MILITARY SPECIFICATION SHEET

TERMINAL JUNCTION SYSTEM, TERMINAL JUNCTION BLOCKS, SECTIONAL, GROUNDING MODULES, STUD AND FLANGE TYPE MOUNTING, SERIES II

This amendment forms a part of Military Specification MIL-T-81714/65, dated 2 March 1968, and is approved for use by all Departments and Agencies of the Department of Defense.

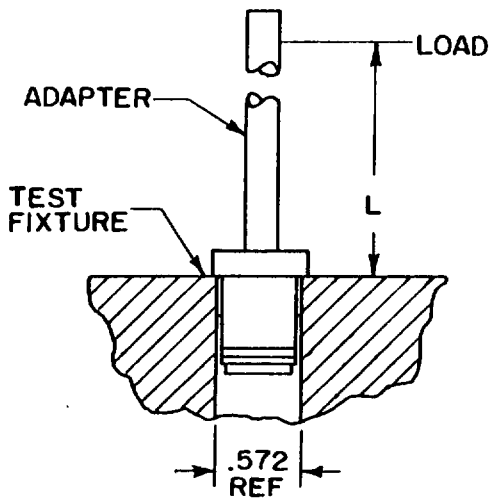
Requirements: Add new requirement for bending moment;

The assembly shall be mounted in a test fixture as shown below with an adapter attached to the stud or flange as necessary. Apply the required load at distance "L" from the test fixture as shown. The load shall create a bending moment of 20 inch-lbs. for sizes 22, 20 and 16, and 30 inch-lbs. for size 12. Apply the load at a rate of approximately 1 lb. per second until the required force is achieved and keep it applied for 15 seconds before releasing. There shall be no evidence of separation between the housing and the stud or shell base, or any other damage detrimental to their normal operation.
